Brine Tank Standpipe ModificationUNIT 0☐ QA-SCOPE☒ NON QA-SCOPE

Brine Tank T-118 Standpipe Modification
Originator: Elizabeth Hellman

IWP 92-008*Q-02
Non-QA
January 31, 1997

ECR# 97-0008		Sheet 1 of 3 + sketch (3 sheets)
Project Manager: Elizabeth Hellman	Mod#/Affected Document #: MR 92-008*Q	<input type="checkbox"/> QA <input checked="" type="checkbox"/> Non-QA
Reference Documents: IWP 92-008*Q		
<p>Problem Description and Proposed Changes:</p> <p>MR 92-008*Q was initiated in part to provide a means of overflow protection independent of the normal level control system for the Water Treatment System Brine Tank, T-118. The installation of an ultrasonic, gap sensor-type level switch in the brine tank standpipe and a high-high level alarm provided the independent overflow protection. However, questions remain as to how accurately the level in the standpipe reflects the level in the bulk of the tank. Thus, the ability of the high-high level switch to prevent brine from overflowing the tank is questionable.</p> <p>The proposed change is to implement some means of improving the accuracy with which the standpipe level reflects the bulk tank level.</p> <p>Preliminary Approval By/Date: N

SK-92-008*Q-04 Sh. 1 of 3
Brine Tank Standpipe
Modification

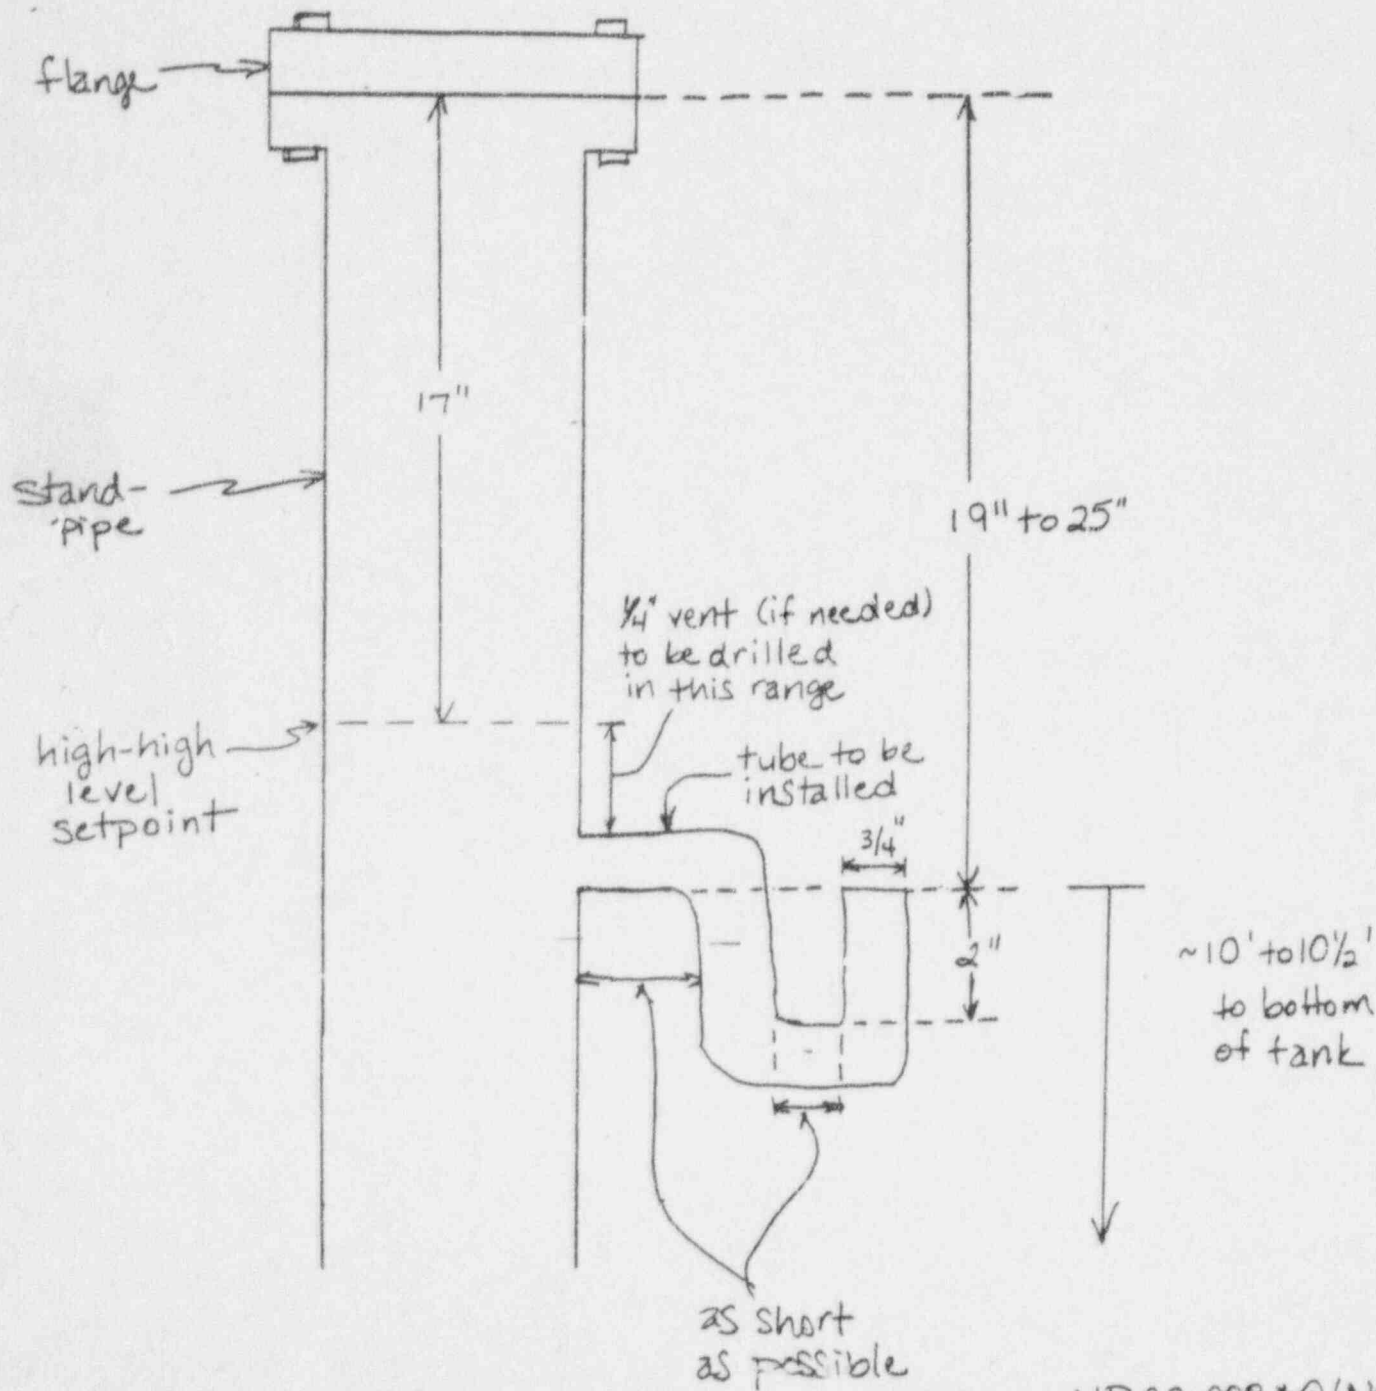
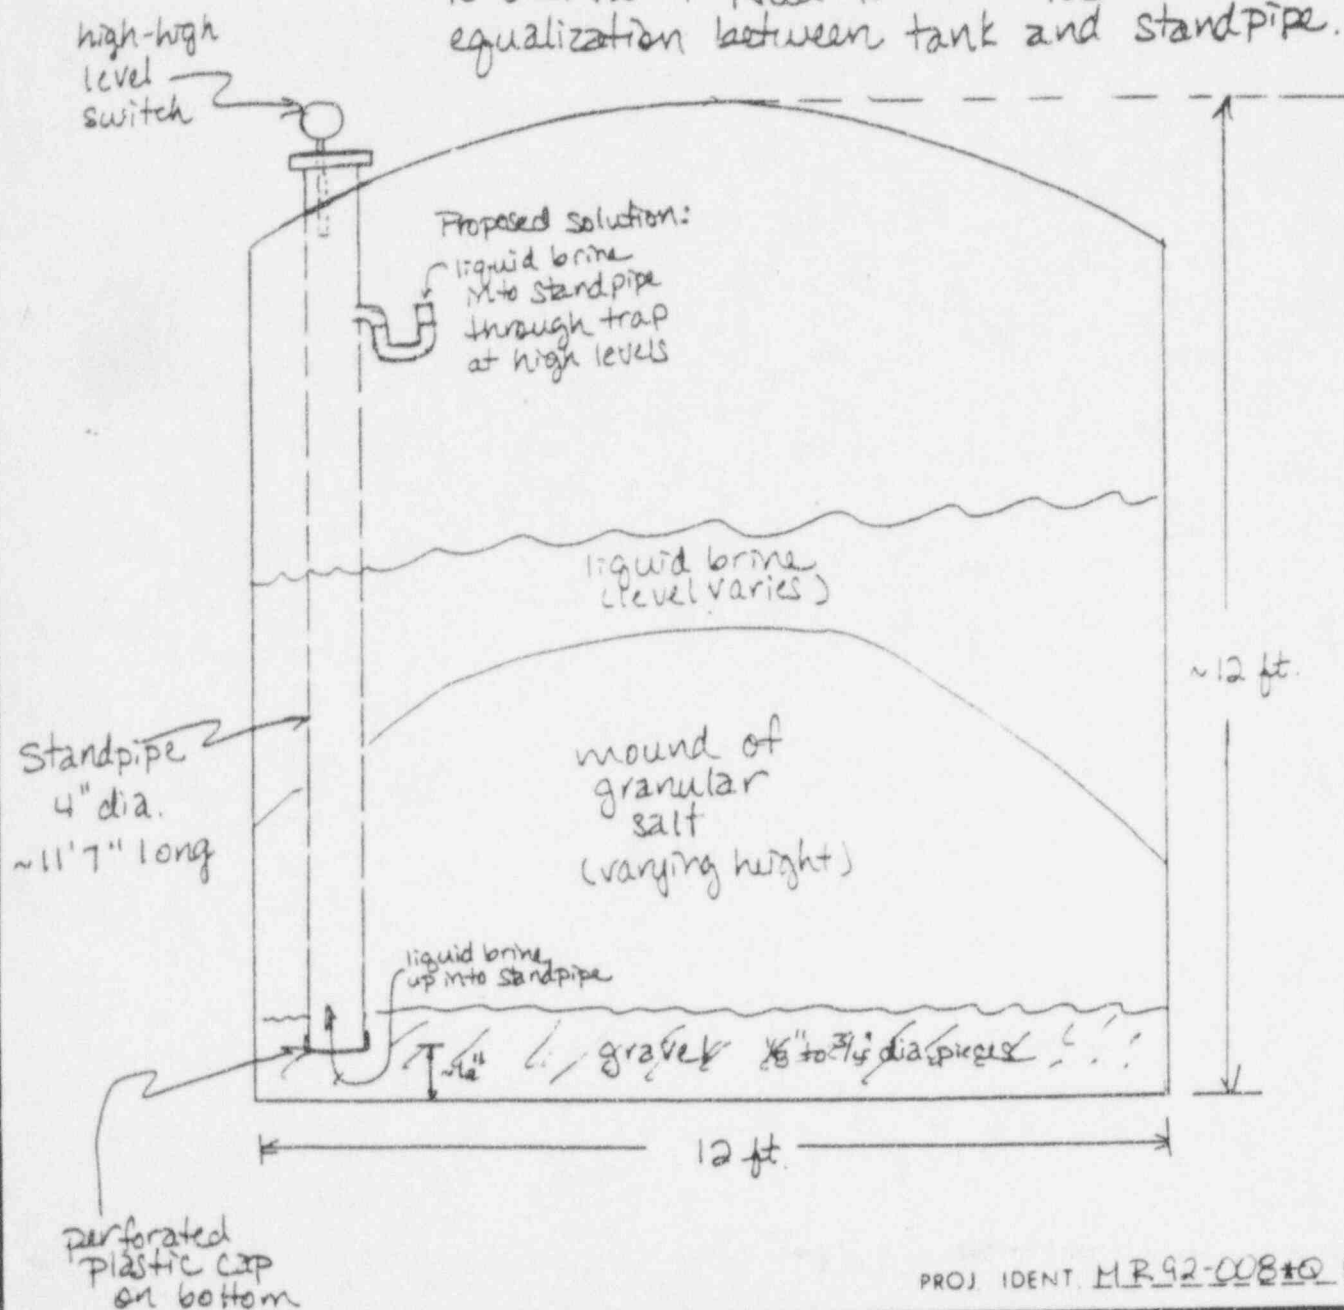
In order to improve the accuracy with which the standpipe level reflects the bulk tank level, the brine tank standpipe will be modified to facilitate brine transfer from the bulk of the brine tank to the standpipe. This modification involves cutting a hole out of the wall of the standpipe and attaching a U-shaped tube to the outer wall of the standpipe at the location of the hole. The U-tube will contain water or brine at all times to trap and dissolve salt before it can enter the standpipe and coat the high-high level switch probe.

The hole and U-tube should be located low enough on the standpipe to ensure that level equalization occurs in time for the high-high level switch (LE-9212) to prevent overflow yet high enough so as to minimize the exposure to the salt mound. To ensure that the U-tube remains filled with liquid, the tube should be placed within the range of the de-ionized water spray in the tank. Since the high-high level setpoint is located 17 inches below the flange on the standpipe (which equates to about 2 inches below the straight side of the tank), the hole should be drilled at least 2 inches below the setpoint for an extra margin of safety. (During a salt delivery to the brine tank, the liquid level in the tank takes at least one minute to rise 2 inches. Based on Calculation # 97-0031, an 18-inch level difference can be made up within about ^{100s?} 2 seconds.) The hole may need to be lower depending on the spray water coverage. Therefore, the hole should be located 19 to 25 inches below the flange on standpipe (or 10 to 10.5 feet above the floor of the tank). If the existing vent hole in the side of the standpipe is in that range, it should be enlarged to accommodate the attachment of the U-tube and a new, smaller vent hole of approximately 1/4 inch in diameter shall be drilled in the standpipe wall as indicated on Sketch SK-92-008*Q-04.

MICROFORM NO		 Wisconsin Electric		TITLE	
				SK-92-008*Q-04 sh. 3 of 3 Brine Tank Standpipe Modification	
DRAWN EAH	DATE 11/31/97	APPRVD.	DATE		
CHECKED		APPRVD.			
DRAFTG.		APPRVD.			
SCALE A				RELEASE DATE

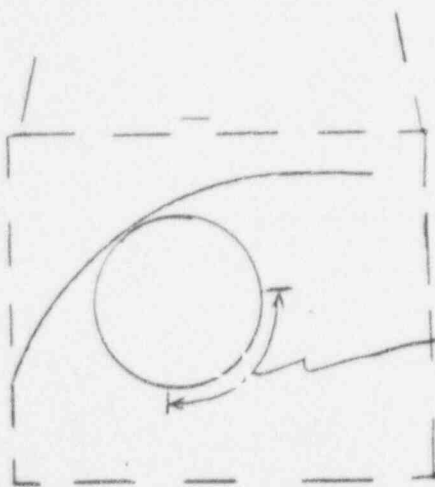
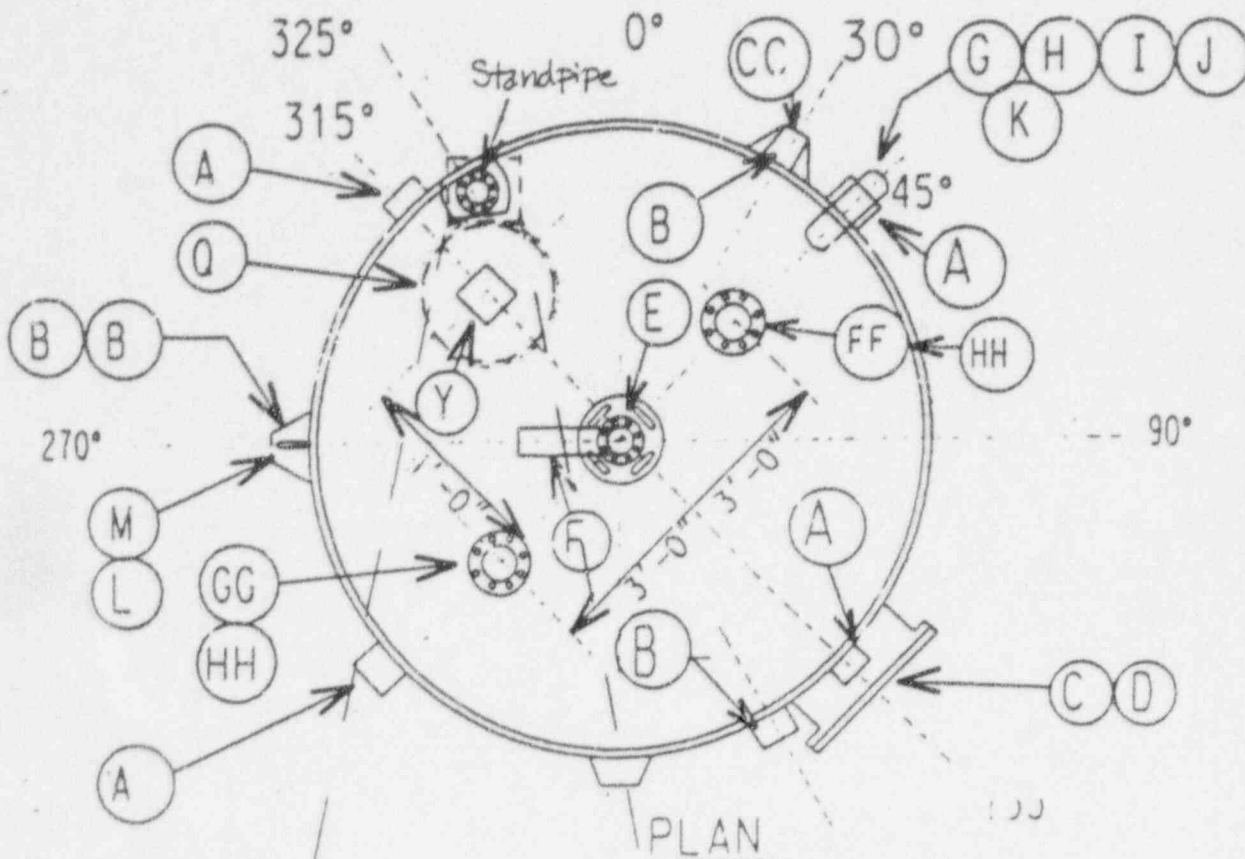
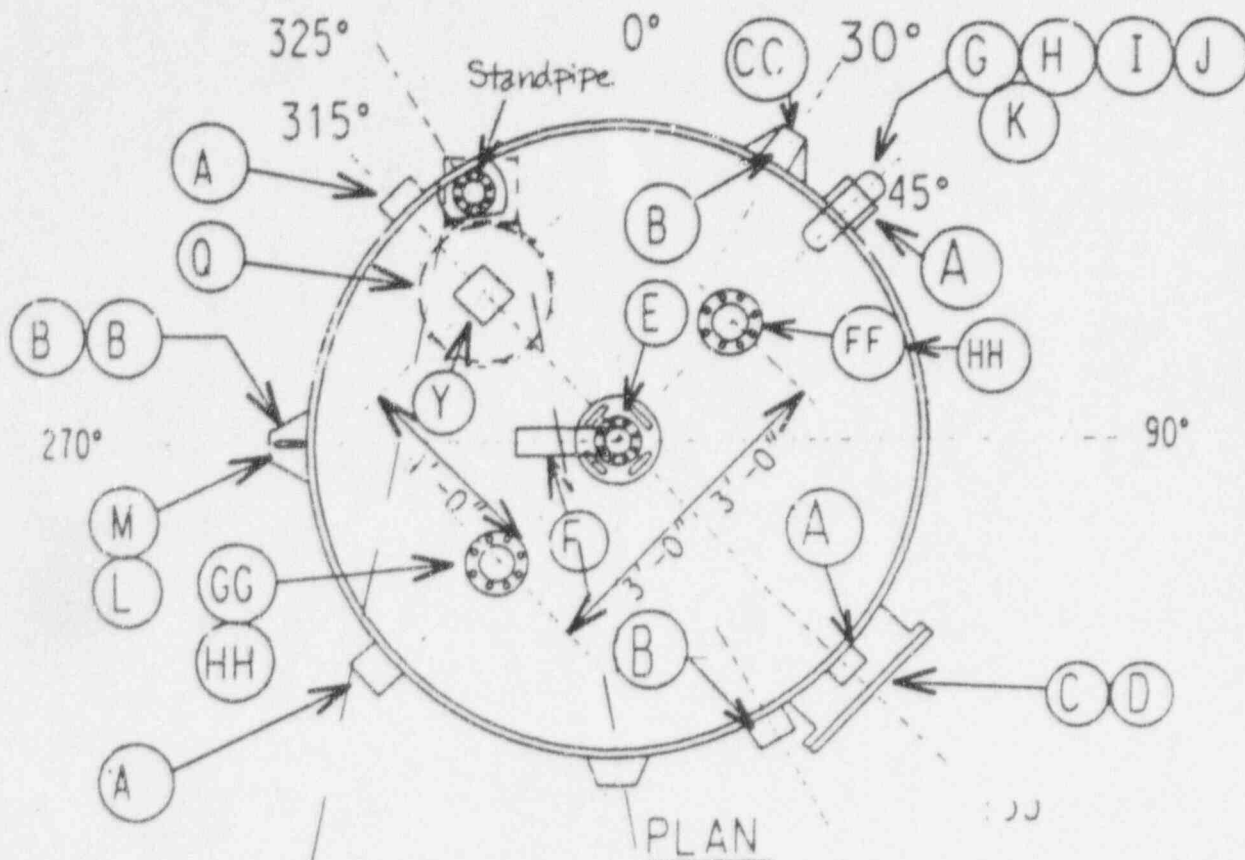
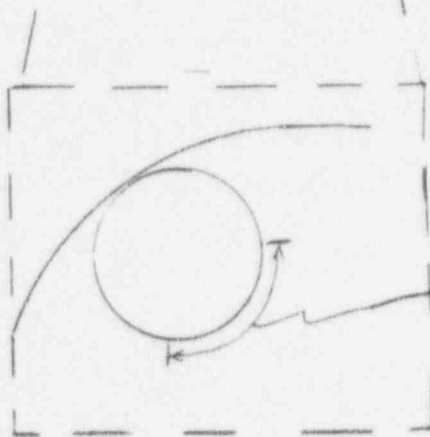
Position U-tube
and vent (if needed)
in this range.

Position U-tube
and vent (if needed)
in this range.
